UNITED STATES PATENT AND TRADEMARK OFFICE

10/613,646

Office Action Summary	Application No. 10/613,646	Applicant(s) PHILLIPS ET AL.	
	Examiner JAN CHRISTOPHER MERENE	Art Unit 3733

4. **Claims 17-19, 22-24, 27-28** are rejected under 35 U.S.C. 103(a) as being unpatentable over Bookwalter et al US 5,424,724 in view of Kubicki et al US 5,171,927.

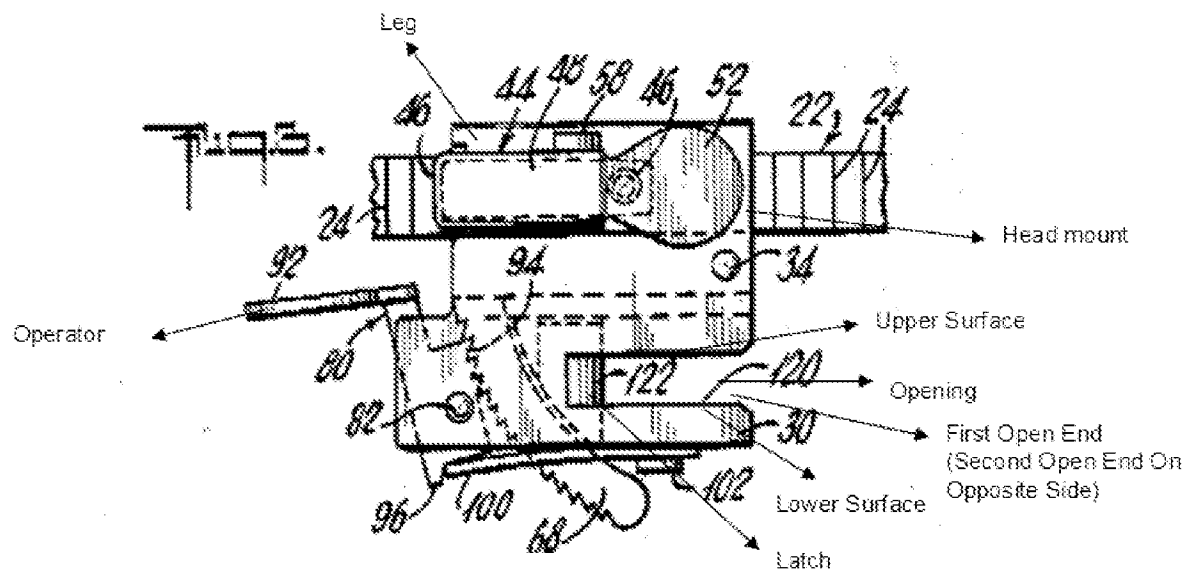
a latch connected to the clamp for selectively retaining the clamp at a selected position on the arm, the latch engages the tooth of the arm (see Figs below and see Col 4 lines 40-45);

an angularly adjustable leg pivotally coupled to the clamp about a pivot axis that is parallel to the axis of the opening, wherein the leg pivots relative to the upper surface of the opening and the lower surface of the opening, the leg having a retractor blade connector head mount for receiving a connector head of a retractor blade, where the leg extends cantileveredly away from the clamp (see Fig below and Fig 2); and

an operator connected to the leg to adjust the angular position of the leg with respect to the clamp, wherein the operator adapted for rotation to allow incremental movement of the leg relative to the clamp, where the operator moves the leg relative to the clamp (as seen in Fig below and see Col 4 lines 15-25, where the operator pivots the arm, wherein the opening has a first open end and a second open end with an axis, where the pivot axis is parallel to the axis).

However, Bookwalter discloses a ratchet system to adjust the leg (see Col 4 lines 15-25 and Fig above) but does not specifically disclose the operator comprises a threaded shaft.

With regards to Claim 23, see Fig above where Bookwalter teaches a first and second projection forming a U Shape.
